July 24, 2008

**Re: Remedial Action Plan Addendum  
Operation of Remediation System in Stream Discharge Mode  
Len's Hartsville Garage  
Warwick Township, Bucks County, PA  
DEP Facility ID #09-27935  
Liberty Project No. 060006**

**FIGURE 1**  
**PROCESS FLOW DIAGRAM – STREAM DISCHARGE MODE**

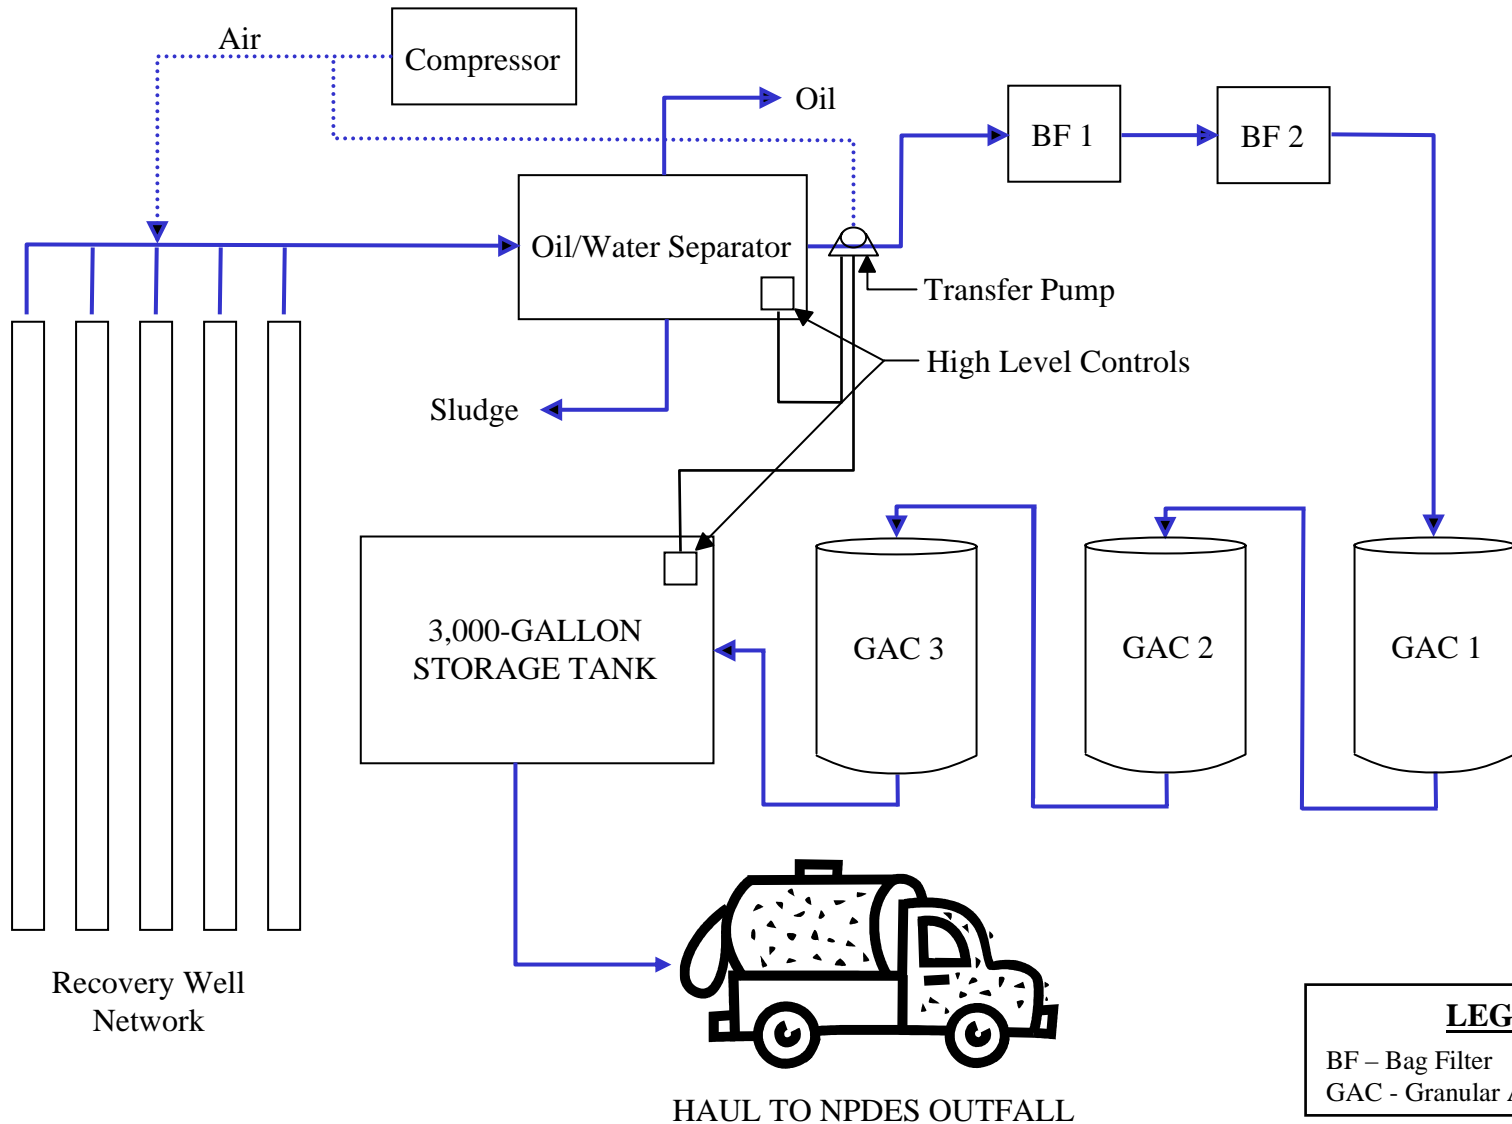
The proposed modifications to the system will include installation of a small oil/water separator to prevent any recovered free product from fouling the activated carbon vessels, and use of the 3,000-gallon oil/water separator as a holding tank for treated groundwater. A diagram of the small oil/water separator that is being installed (AFL Industries model VTC-20A) is attached. The oil/water separator has a flow capacity of 20 gallons per minute (gpm), which is much greater than the average groundwater recovery rate of 1 gpm. After passing through the oil/water separator, recovered groundwater will flow through bag filters for sediment removal, then through three in-series 55-gallon activated carbon vessels for organics removal, and will then be contained in the 3,000-gallon tank. The tank is already equipped with a high-level shutoff device, and an additional device will also be added to the new oil/water separator. These are the only system components that are open to the atmosphere and could overflow in the event of a system blockage.

A process flow diagram and treatment system layout drawing depicting the new system configuration for operation in pump-and-stream discharge mode are included as Figures 1 and 2. A

**FIGURE 3**  
**PROCESS FLOW DIAGRAM – SEWER DISCHARGE MODE**

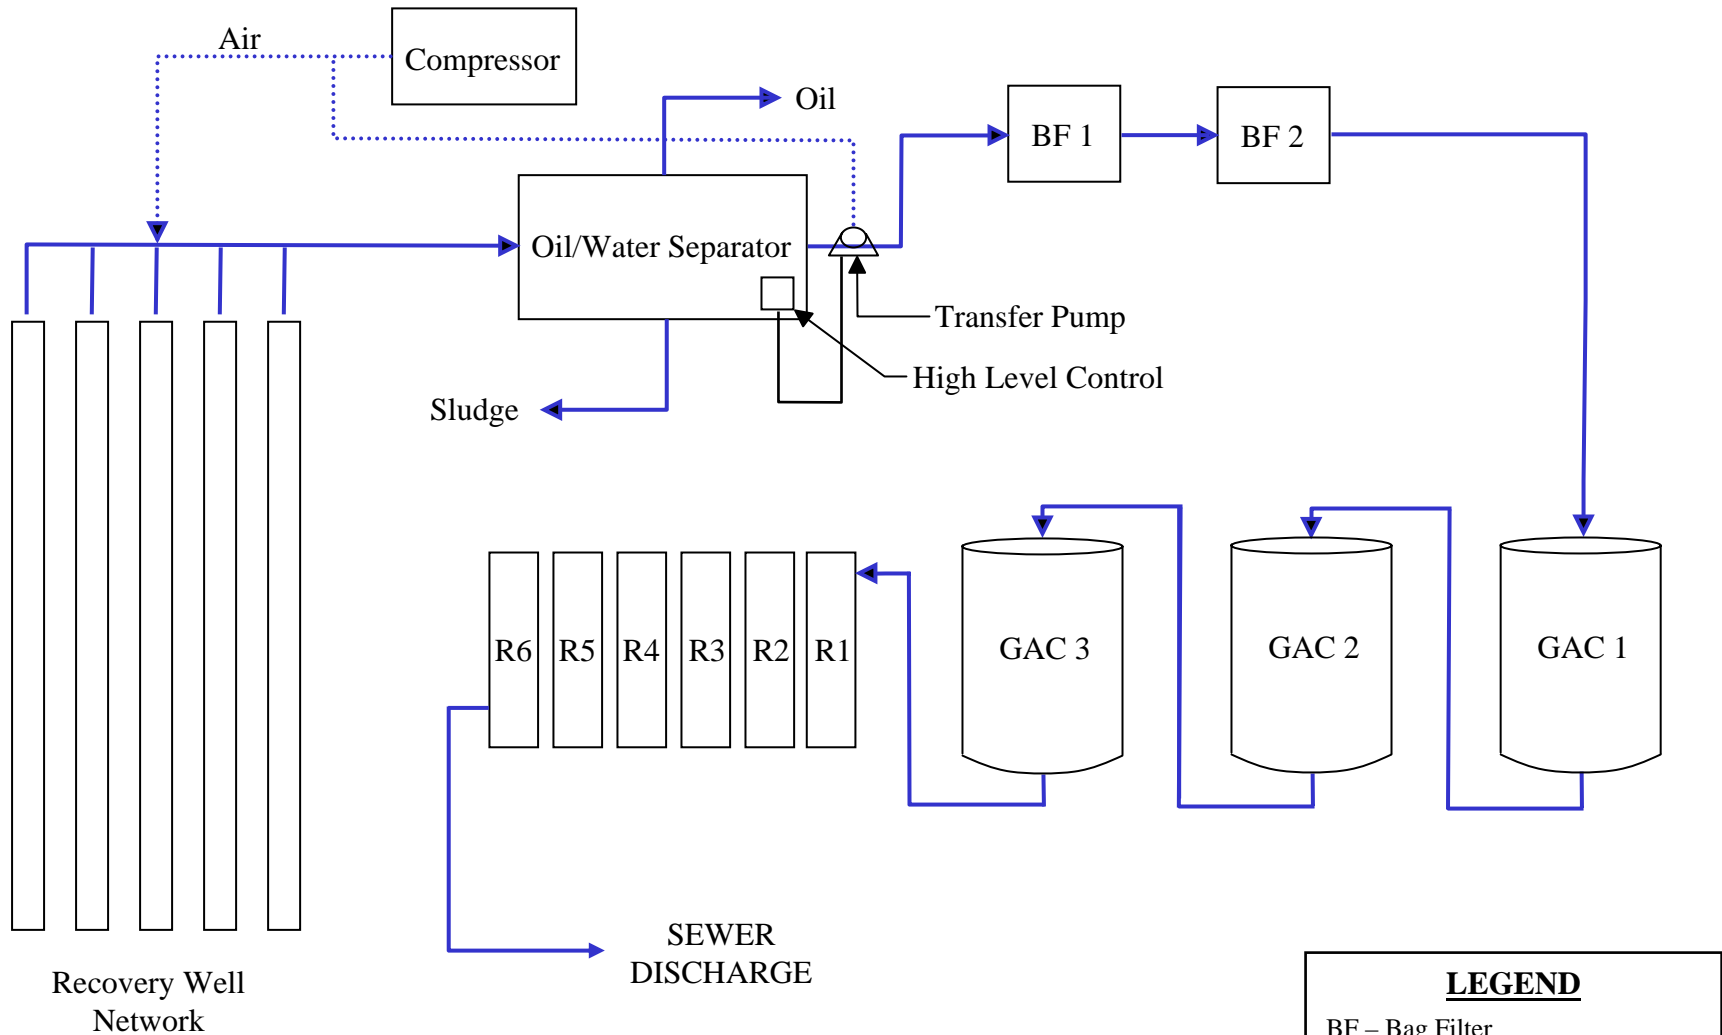
process flow diagram and treatment system layout drawing depicting the new system configuration for operation in pump-and-sewer discharge mode are included as Figures 3 and 4. This configuration will include the ion exchange system for manganese removal that was described in our previous RAP Addendum dated June 16, 2008. One minor change from the ion exchange system described in that RAP Addendum is that instead of using two 55-gallon vessels, we will now be using six smaller vessels that each contains 1.9 cubic feet of ion exchange resin. This change was made to provide a smaller cross-sectional area through the vessel which will reduce the likelihood of channeling occurring in the media.
